**SoHo/NoHo Neighborhood Plan**  
**Final Scope of Work**  
**for an Environmental Impact Statement**  
**CEQR No. 21DCP059M**  
**ULURP Nos. Pending**  
**May 14, 2021**

This document is the Final Scope of Work (the “FSOW” or “Final Scope”) for the SoHo/NoHo Neighborhood Plan Draft Environmental Impact Statement (DEIS). This FSOW has been prepared to describe the discretionary approvals, including zoning map and text amendments (collectively, the “Proposed Actions”), present the proposed framework for the DEIS analysis, and discuss the procedures to be followed in the preparation of the DEIS.

**Figure 5**

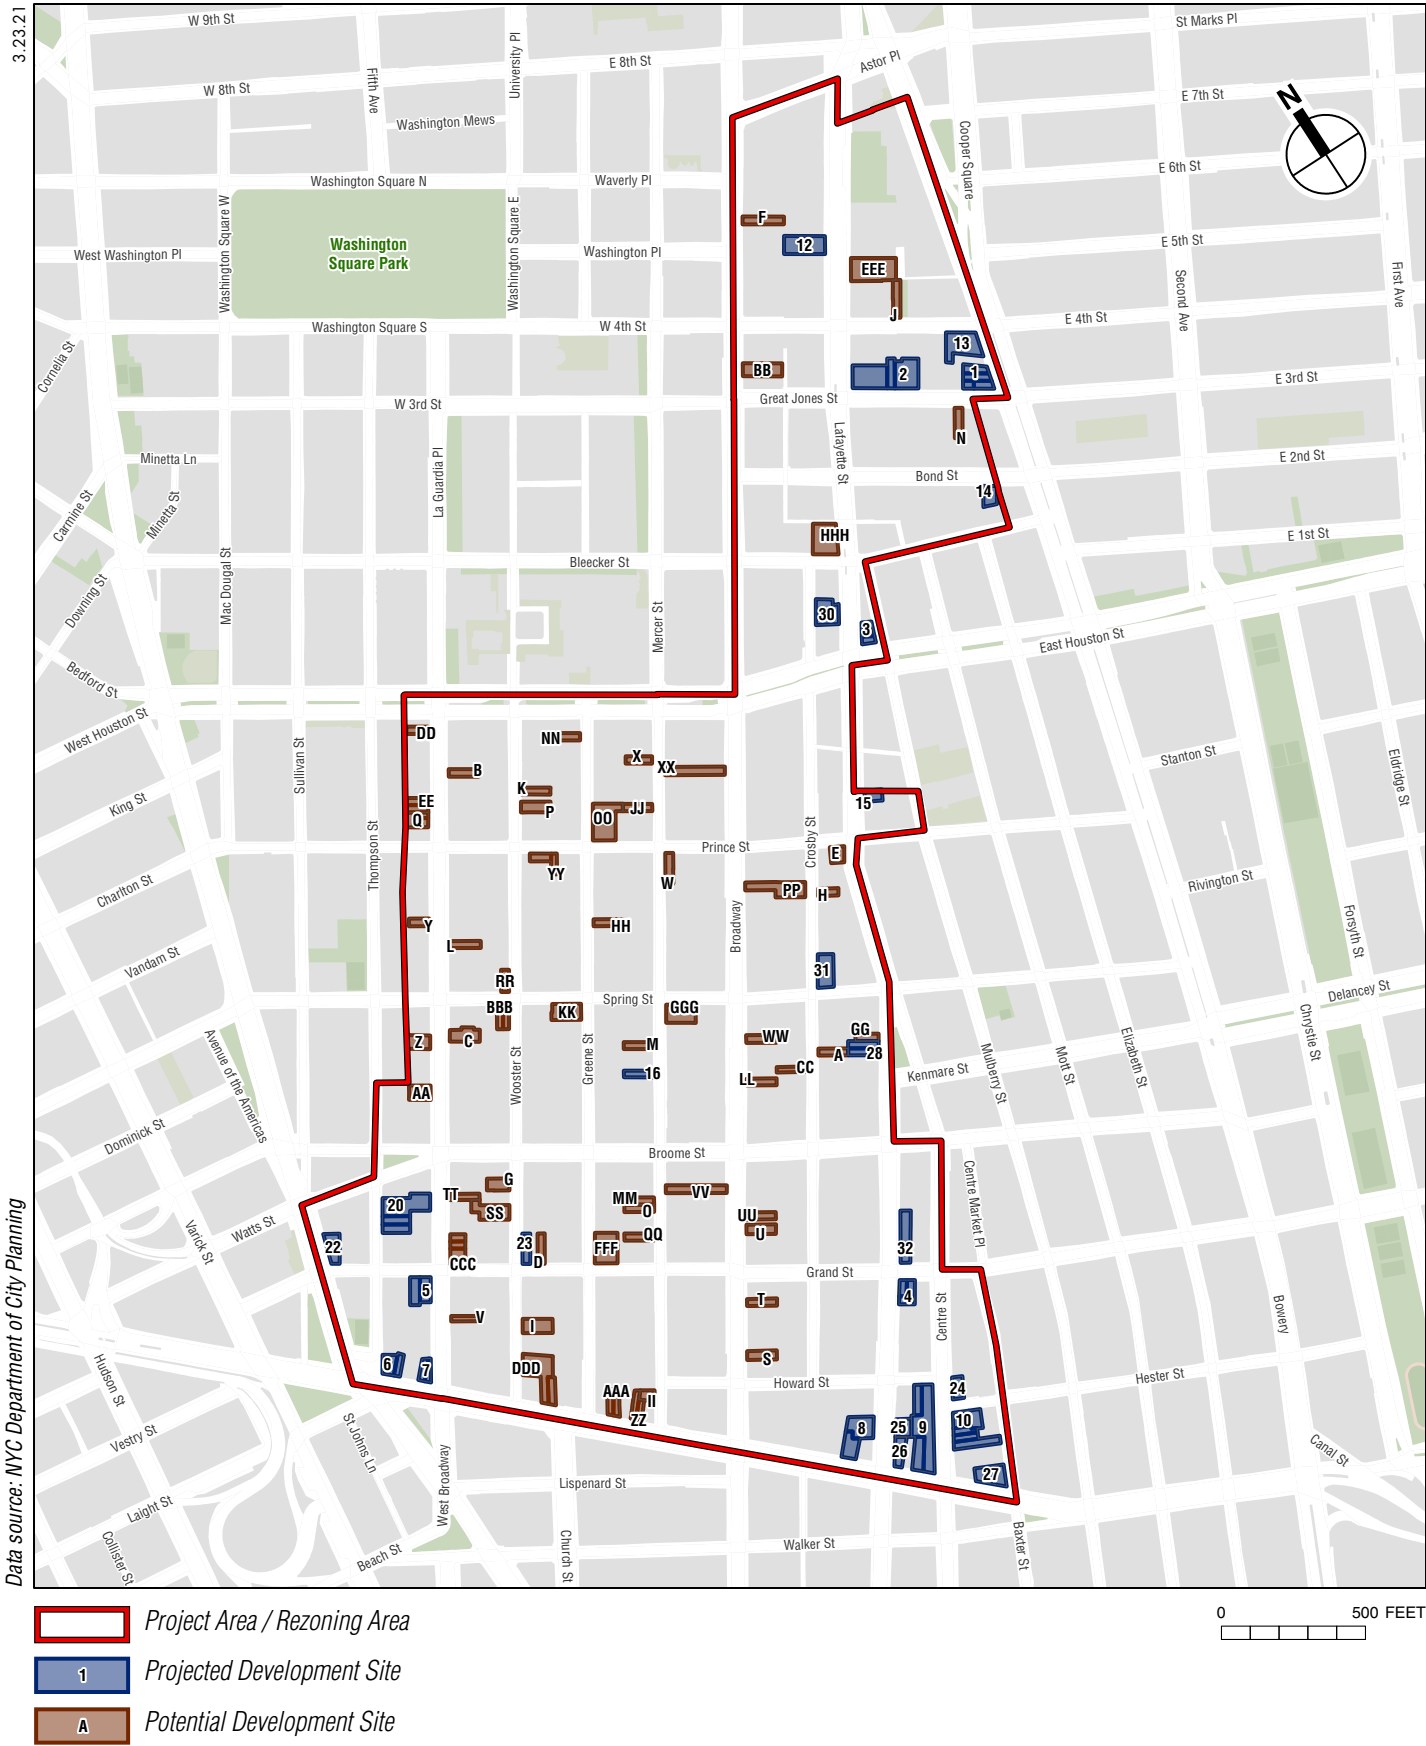
**Comment 376:** Most of the data provided by DCP for the Projected and Potential Development Sites is said to be found in Appendix 1, Tables 1, 2, and 3—all of which is illegible, and therefore functionally nonexistent. Because the DSOW references the data presented in Appendix 1, the usefulness of Figure 5 “Projected and Potential Development Sites” is severely limited. (Davies\_BRC\_151)

**Comment 548:** Figure 5 shows a cluster of Projected Development Sites in the vicinity of West 4th Street and Lafayette Street, projected to see incremental development of around 410 DUs and 48,000 gsf of office space. It seems reasonable to assume that subway customers making six train trips between this part of the Project Area and locations to the north would access the 6 train at Astor Place station. Why is this station not included for analysis? (Popovits\_MTA\_148)

**Comment 549:** Figure 5 also shows a cluster of Projected Development Sites at the southwest corner of the Project Area, between Sixth Avenue and West Broadway. These sites are projected to see incremental development of around 300 DUs and 80,000

Existing Land Use  
**Figure 6**

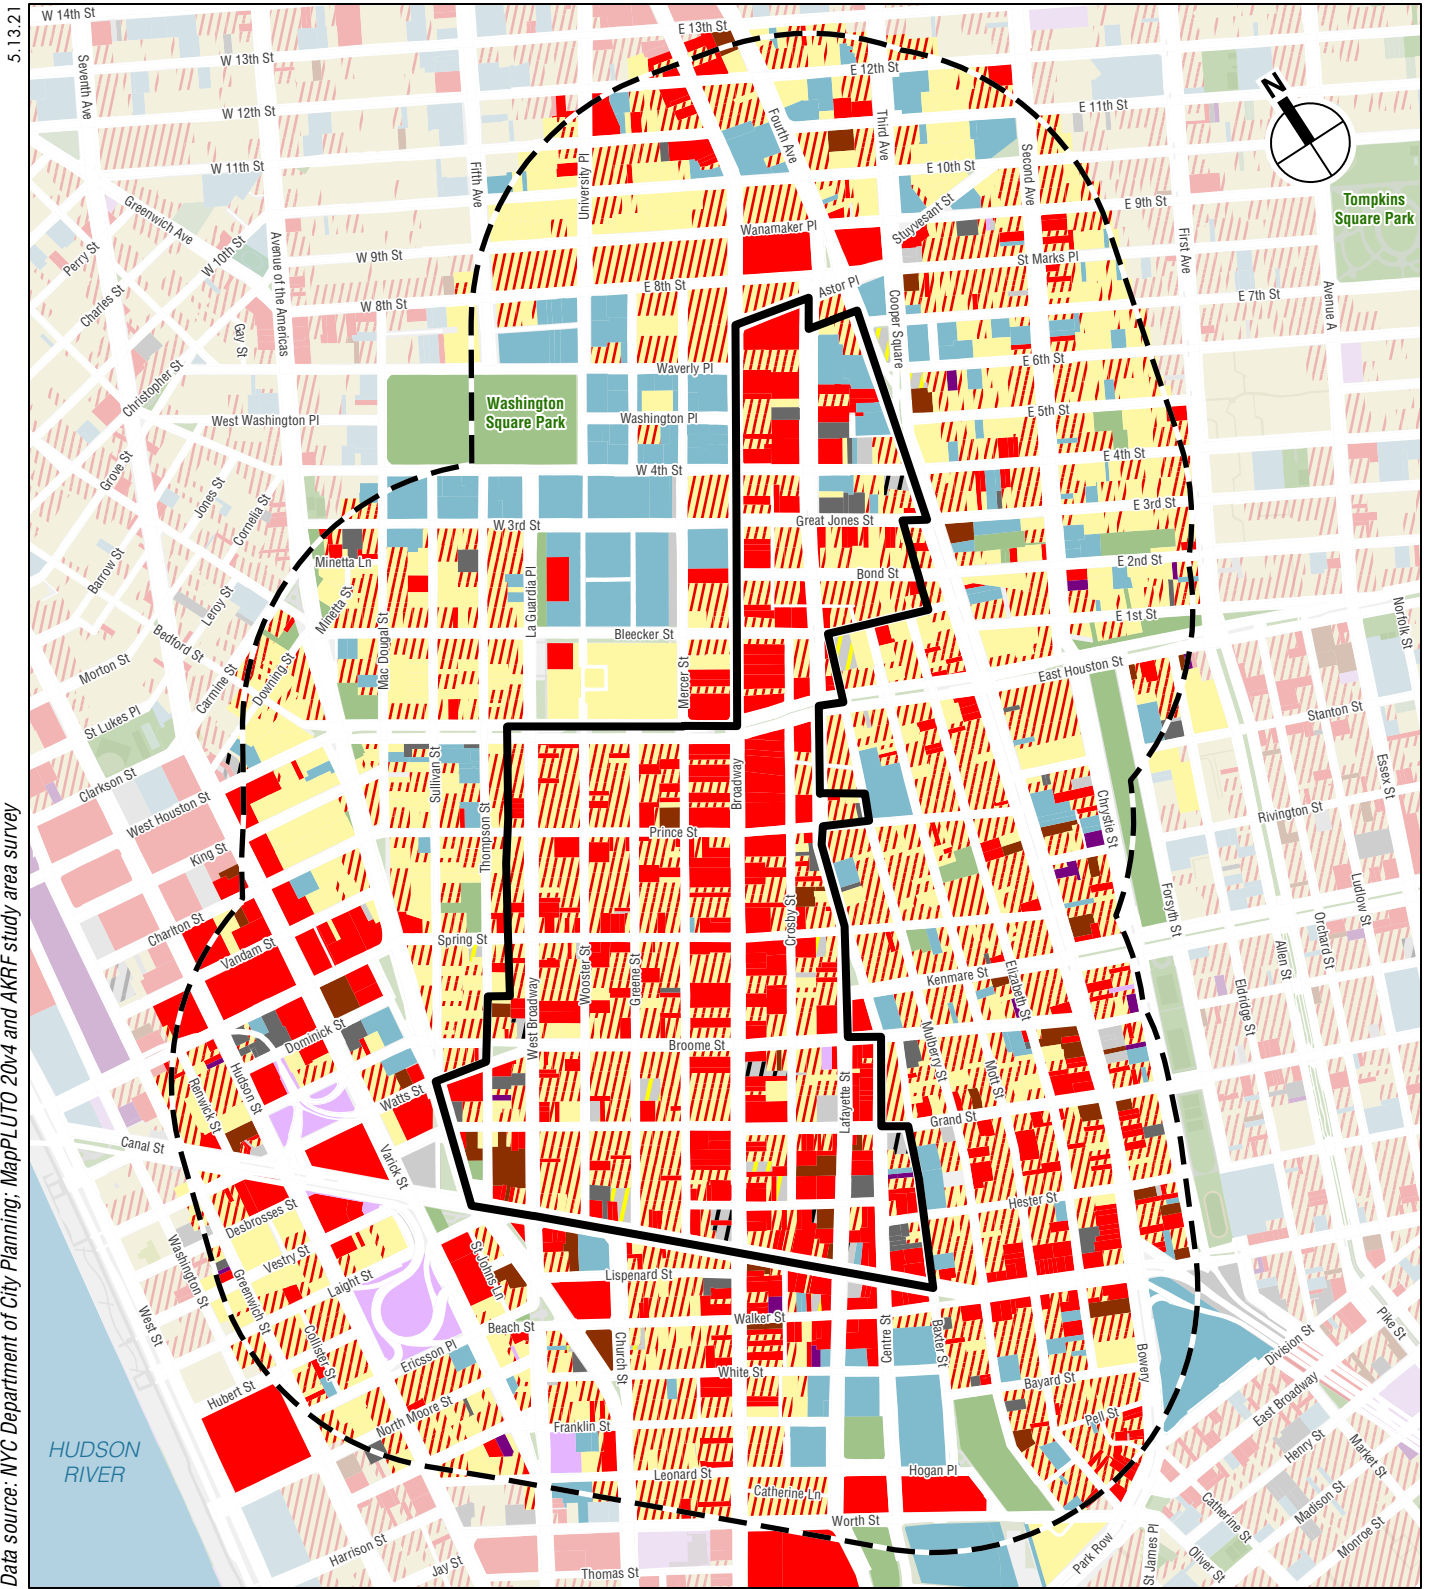
**Comment 367:** Please note that 16 Crosby Street and 452 Broadway are incorrectly labeled as “residential” on the Existing Land Use Figure 6. They should be correctly labeled “residential with commercial below.” (Levy\_117)
